October 3, 1980

Re: Nine Mile Point Unit 2
Docket No. 50-410

Your letter of July 9, 1980 requested additional information regarding geology at Nine Mile Point Unit 2. Enclosed are Niagara Mohawk's responses to questions Q361.26 through Q361.35 contained in the enclosure to your letter.

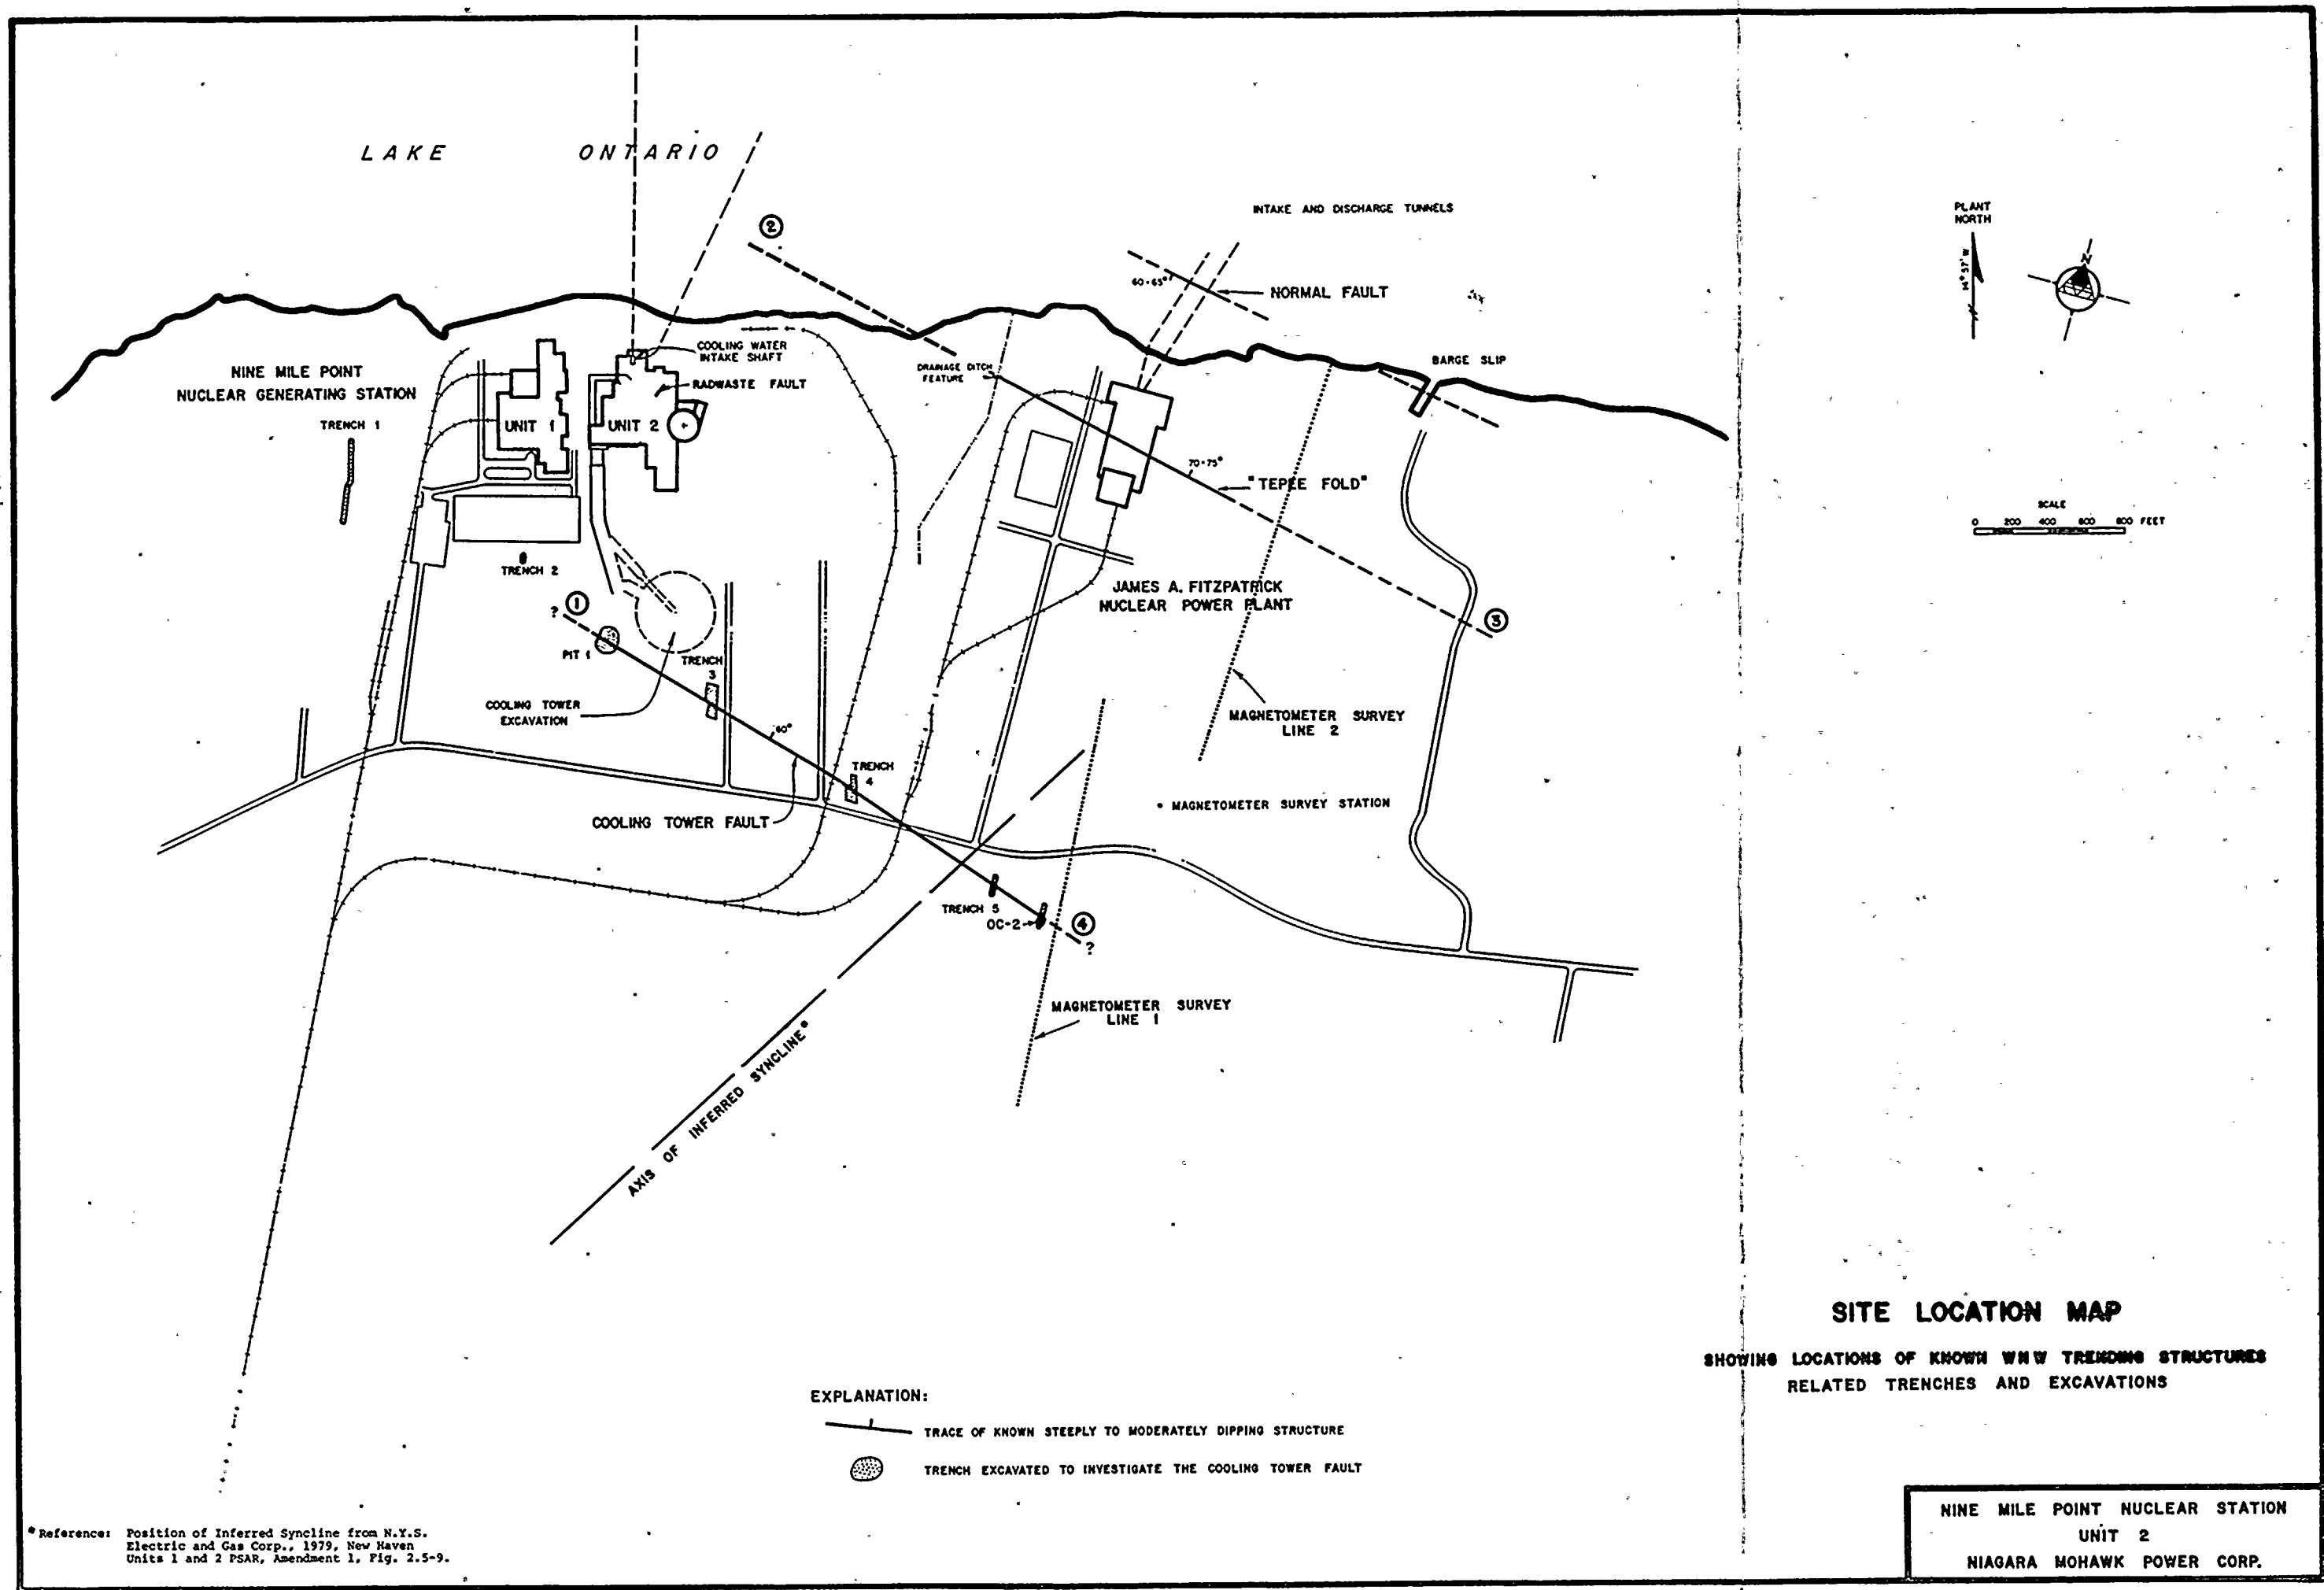
Q361.26 In your report entitled "Nine Mile Point Nuclear Station, Unit 2, Geologic Investigation," (Vol. 1, Section 4.7, paragraph 1), you state that the intensity of the shearing on the cooling tower fault does not appear to diminish toward the known extremities. However, it is not clear from your report where the southeastern extremity of this fault is and where either extremity of the drainage ditch fault is. Accordingly, provide data which will indicate the length of the cooling tower and drainage ditch faults and show their relationship, or lack of relationship, to each other. In your response, consider acquiring this information by running a detailed ground magnetic survey using a field magnetometer (e.g., a proton precession magnetometer). This approach could be followed by trenching, if necessary. If you choose to respond without doing a field survey using a magnetometer, indicate your reasons.

RESPONSE: Figure 361.26-1 summarizes all known observations relevant to the evaluation of the lateral extent of Cooling Tower and Drainage Ditch faults. The apparent west-northwest terminations of both faults are shown on Figure 361.26-1 as locations ① and ②. Location ① is considered to be the western extremity of the Cooling Tower Fault because trenches 1 and 2 revealed no evidence of faulting. These trenches were excavated 700 feet and 1750 feet west of the cooling tower piping trench. Location ② is considered to be the western termination of the Drainage Ditch Fault because the lake water tunnels for Nine Mile Point, Unit II did not encounter the fault.

On the basis of the above information it appears that it is appropriate to assume that the east-southeast extremity of the fault is somewhere around location ③ on Figure 361.26-1.

The minimum lateral extent of the Cooling Tower Fault as determined by our investigation is approximately 3000 feet. As shown on Figure 361.26-1, this corresponds to the distance between Pit 1 and the overcoring Borehole OC-2. With the data presently available, it is difficult to place the east-southeast extremity of the fault. However, the Cooling Tower Fault in terms of the magnitude of displacement and degree of cataclasis appears to be very similar to the Drainage Ditch Fault. Hence, it is difficult to envision the lateral extent of the fault as being significantly different than the length of its analog. This suggests that the Cooling Tower Fault does not extend beyond location ④ on Figure 361.26-1.

To illustrate this, proton magnetometer surveys were conducted across the Cooling Tower Fault and Drainage Ditch Fault (Figure 361.26-1). As shown on the magnetometer profiles (Figure 361.26-2) no pronounced gradients are apparent that would suggest the location of the fault at the surface or at a hypothetical projection to the basement.

FIGURE 361.27 - 1

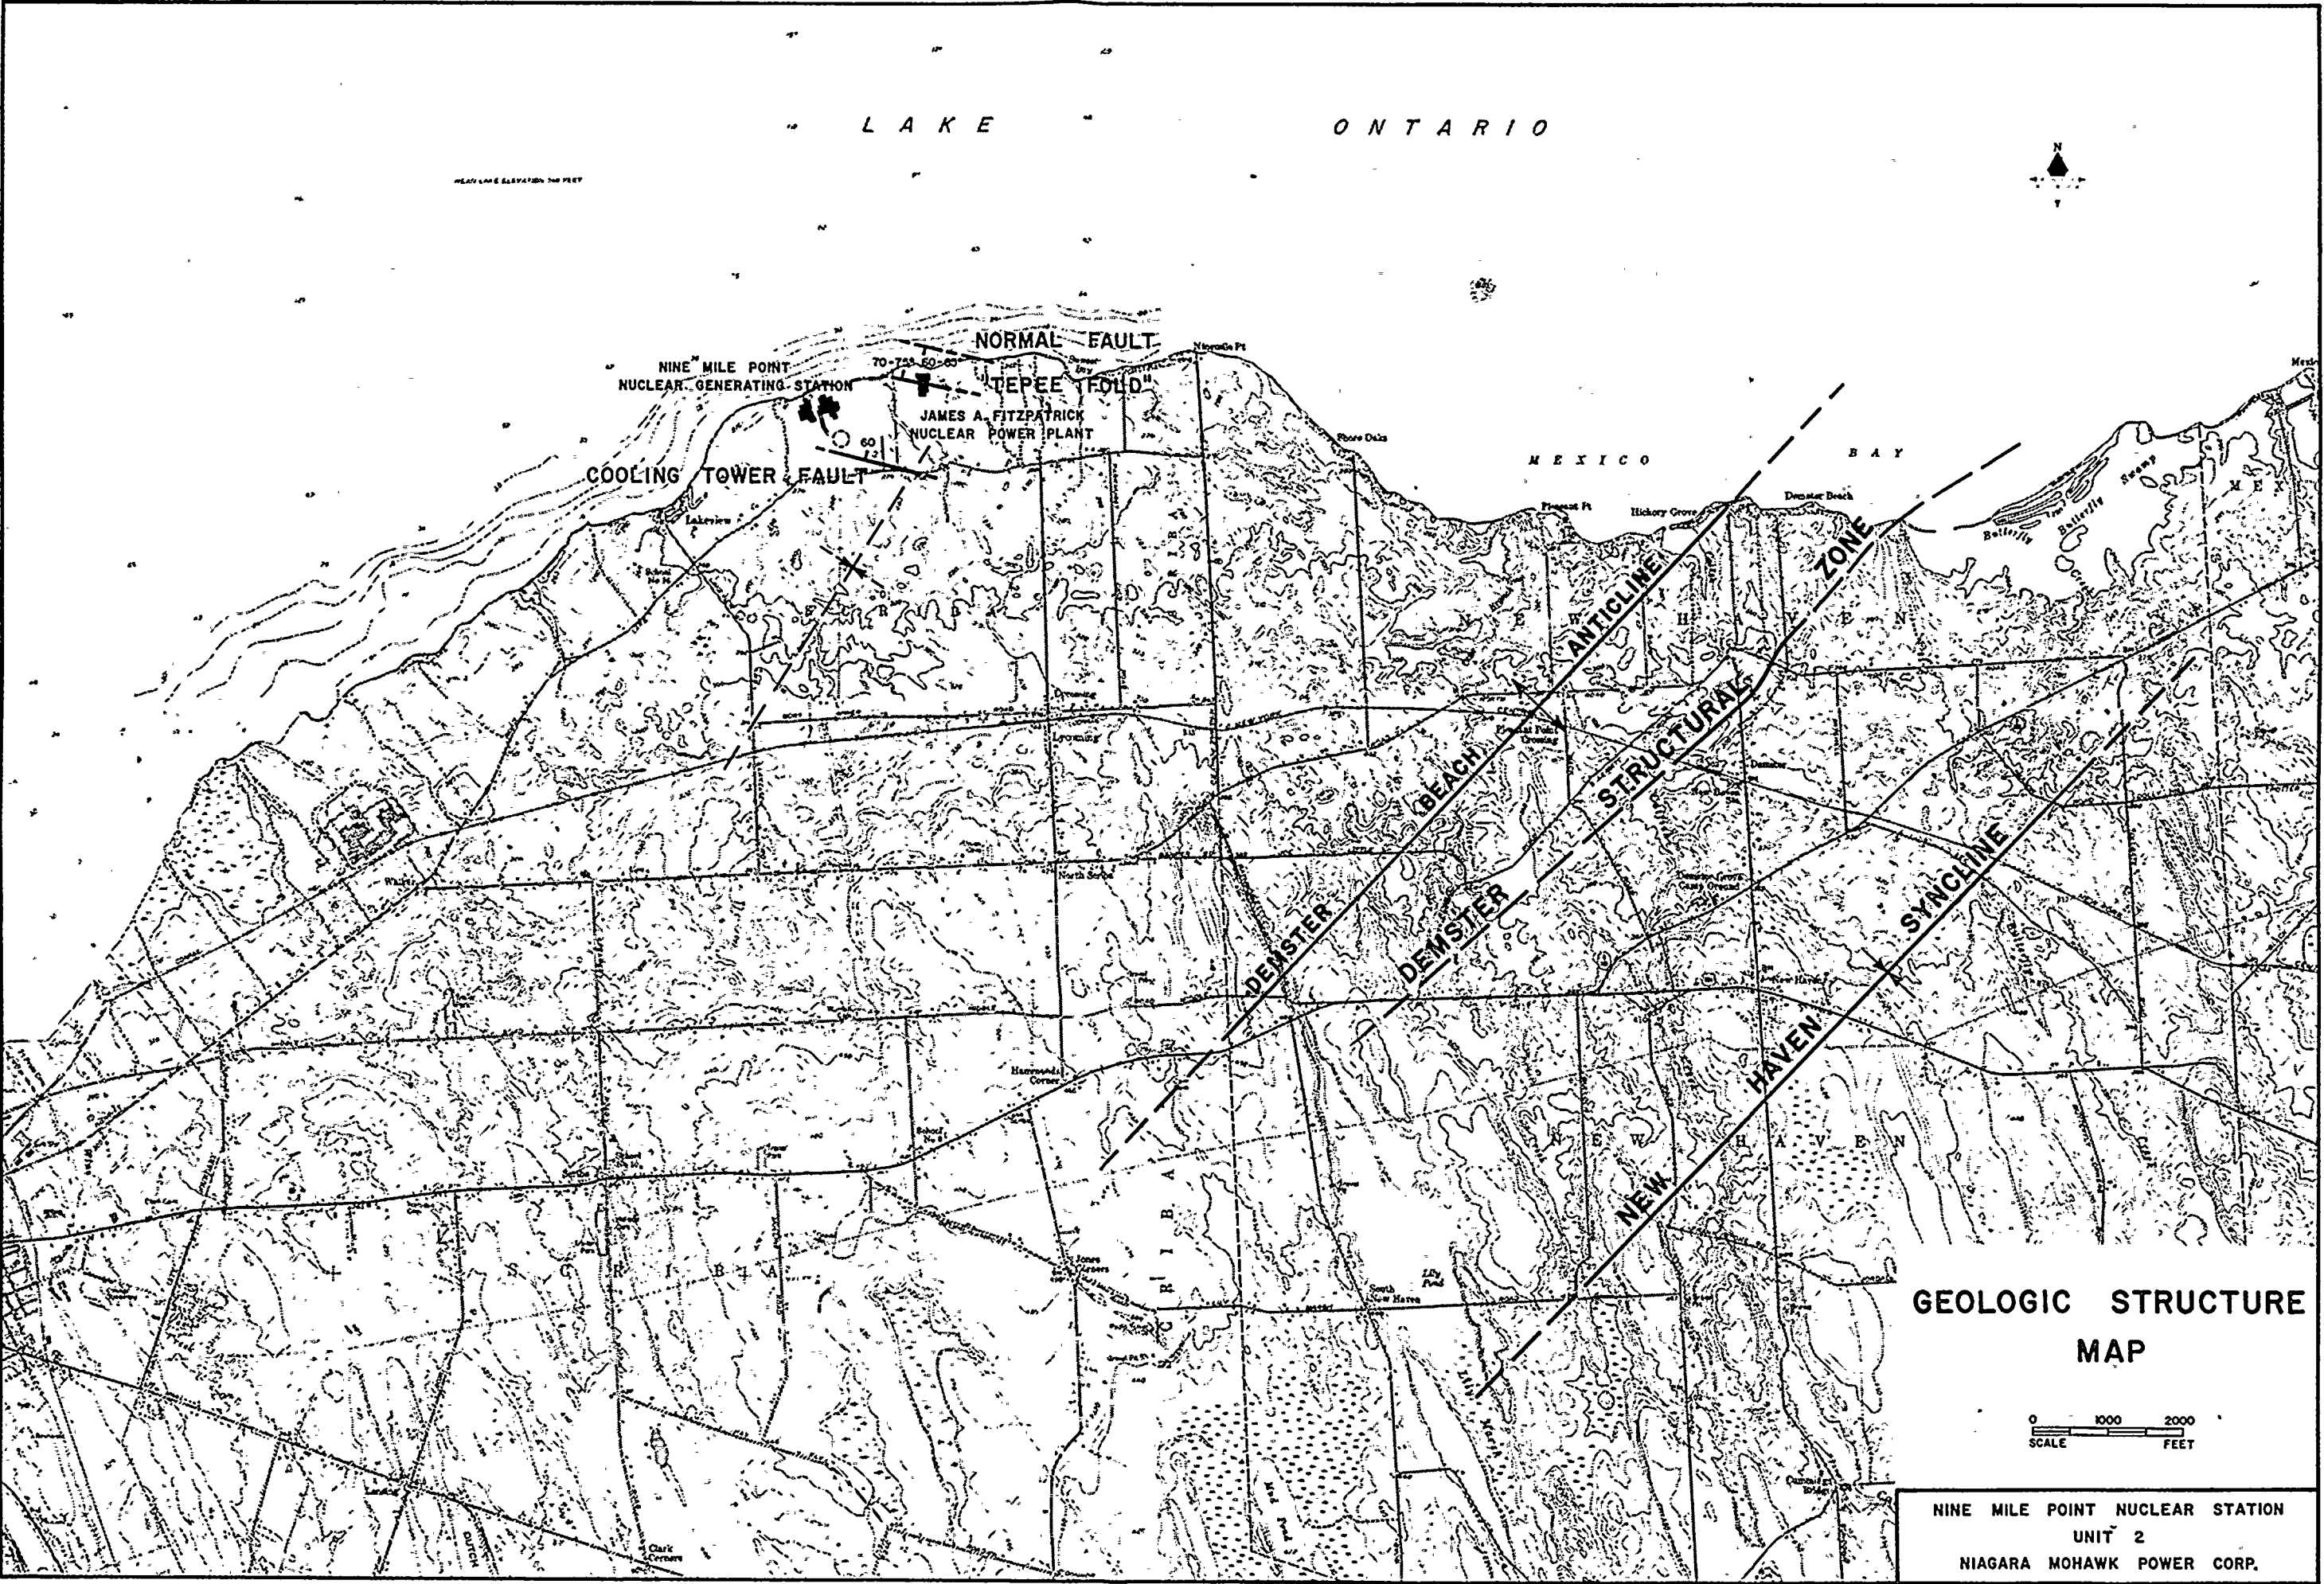
Q361.27: Indicate spatial and age relationships of the faults at Nine Mile Point to the geologic structures at the site proposed for the New Haven facility and to other geologic structures in the region. Furnish a map and the necessary data to support your conclusions.

RESPONSE: In the region immediately around the Nine Mile Point Site (30 mile radius) there is only one structure known. This structure, located near New Haven, New York is known as the Demster Structural Zone. Figure 361.27-1 is a map showing the spatial relationship of the faults at Nine Mile Point to the Demster Structural Zone.
